## Indian Springs Phase I Sewer & Water Systems Extensions

Regarding: Indian Springs Phase I Sewer & Water Systems Extensions –  
Bidder Questions 1

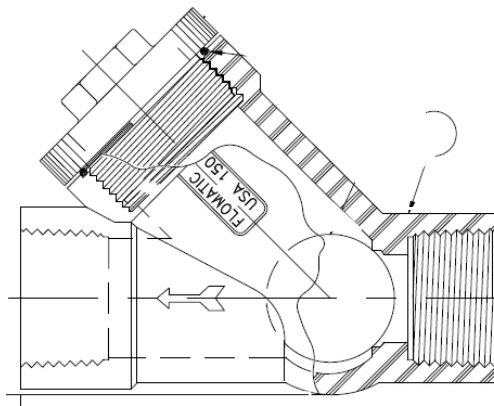
**Question #8:** As check valves are used in cleanout assemblies, may ball-check valves manufactured by Flomatic Valves be used on the Indian Springs project?

The Indian Springs project specification does not address ball-check valves. However, ball-check technology was created in the 20<sup>th</sup> century specifically for wastewater applications. They are simple valves with a single replaceable moving part, a ball. A ball-check can provide both the functionality of a flow checking device and the functionality of a cleanout port. To this product may be added a curb stop to create a valve/cleanout station.

Although the proposed check valve is made from materials other than those listed for check valves in the project specification, Ruffin requests that Flomatic ball-check valves be considered an “Or Equal” for the Indian Springs project per Section 7.04 “Or Equals” of the General Conditions. That is, that Flomatic poly ball-check valves are “functionally equal to that [check valve] named”, and that it is believed to satisfy the approval criteria of Section 7.04.A.1.a, paragraphs 1) through 4).

**No. They must be stainless steel and as specified in the Bid Plans and Specifications**
